Final Environmental Impact Statement for the Lund Hill Solar Energy Project

Lund Hill Solar Energy Project
Final Environmental Impact Statement

Klickitat County Planning Department
228 W Main Street, MS: CH-17
Annex 1
Goldendale, WA 98620
Telephone: 509-773-5703
Fax: 509-773-6206

- **Corrections and Modifications to the Draft EIS** – Identifies changes made to the Draft EIS based on comments received
- **Comments and Responses to Comments** – Provides copies of all comment letters received, along with Applicant responses to all comments

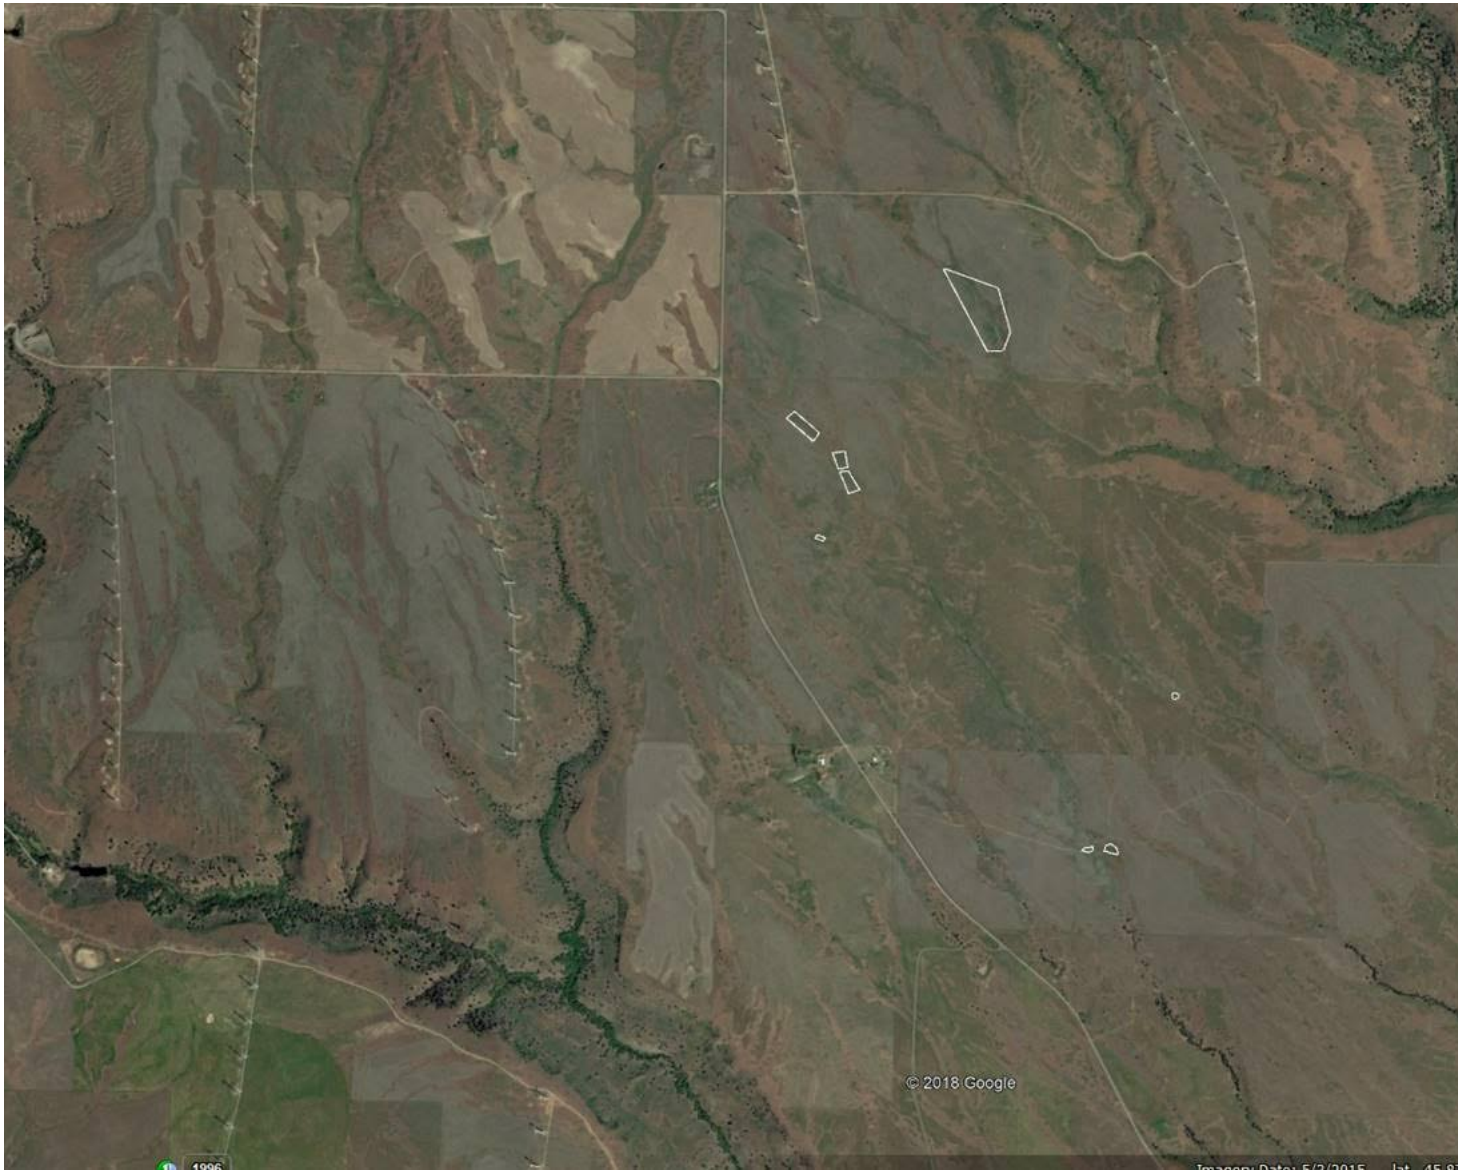
A few additional areas of interest was observed during Ecology's review of the wetland delineation. The areas of interest did not have data sheets provided. Ecology would like to inquire if the areas highlighted below were investigated and if a data sheet could be provided. If they were not previously sampled, could they be?

Ecology recommends the County request additional investigation of the areas identified below. In addition, wetland habitats located within 300 feet of the project site boundary should be rated

DOE/Gwen Clear	DOE-002	Wetlands	<p>The provided wetland delineation report determined 30 wetlands and 22 streams occur within the Lund Hill Solar Project site.</p> <p>A few additional areas of interest were observed during Ecology's review of the wetland delineation. The areas of interest did not have data sheets provided. Ecology would like to inquire if the areas highlighted below were investigated and if a data sheet could be provided. If they were not previously sampled, could they be? [see map: DOE 05282019_map screenshot.pdf]</p> <p>Ecology recommends the County request additional investigation of the areas identified below. In addition, wetland habitats located within 300 feet of the project site boundary should be rated per Klickitat County Code Ordinance No. 0080613 to determine the extent of required wetland buffer habitat.</p>	<p>Highlighted additional areas that were noted in DOE's map screenshot from 5/28/2019 were part of the overall wetland survey. Descriptions of data gathered at the specific identified locations, and references to the locations where this information can be found in the wetland delineation report as appropriate, are provided in the separate accompanying response table. Because all identified areas were included in the wetland survey, no additional investigation is warranted.</p> <p>All delineated wetlands were delineated per guidance in the USACE Arid West Supplement. The USACE Regulatory Guidance Letter 05-05: Ordinary High Water Mark Identification was used for assessing and delineating potential streams. All delineated wetlands were categorized using Ecology's 2014 Washington State Wetland Rating System for Eastern Washington. Wetland buffer widths were determined based on the wetland categories and are consistent with buffer widths in the Klickitat County Code Ordinance No. 0080613. See the accompanying supporting documents: wetland rating forms (prepared as part of the project wetland delineation report), and summary table with wetland ratings and buffer widths (summarizing information prepared for the wetland delineation report).</p>

Potential Gravel Pit Locations

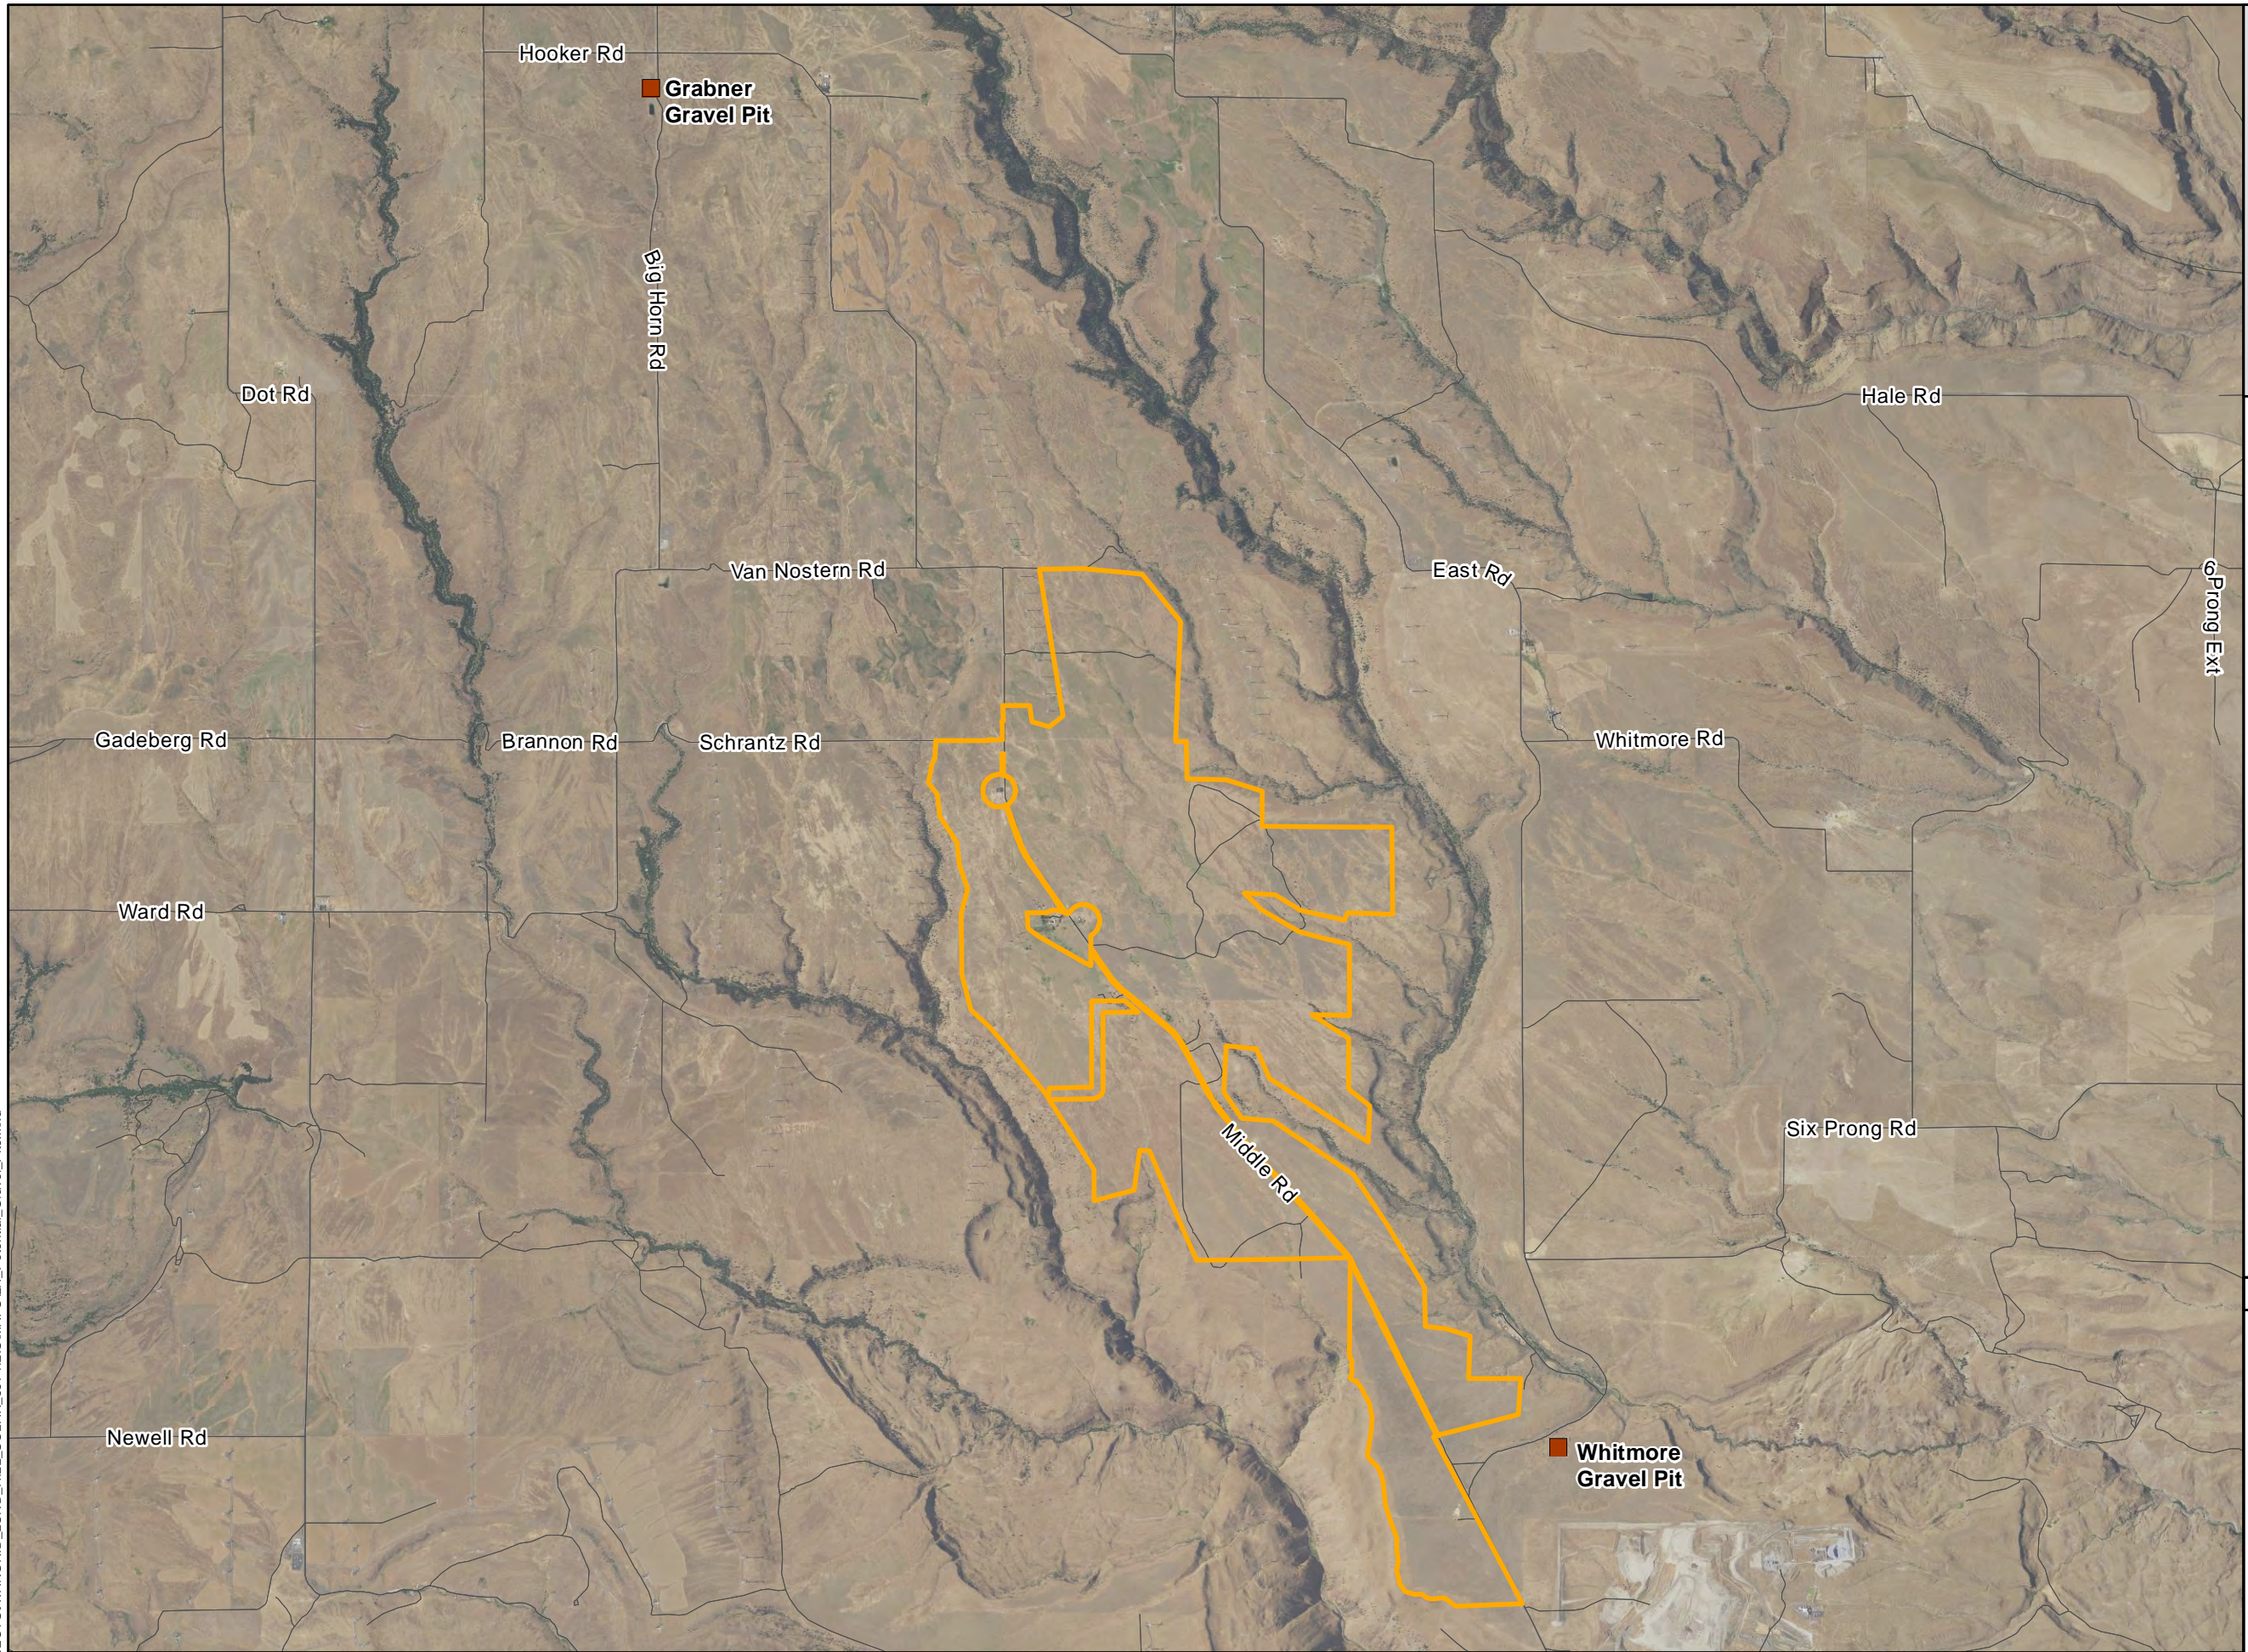
On page 1-4, reference is made to a portable rock crusher. Unless I missed it, the document didn't state whether they planned to use an existing rock pit or if a new pit needed to be developed. A new pit needs to be shown on the maps. If an existing pit, then perhaps it should be shown, also, so I can know which way all the truck traffic will be going and plan accordingly.
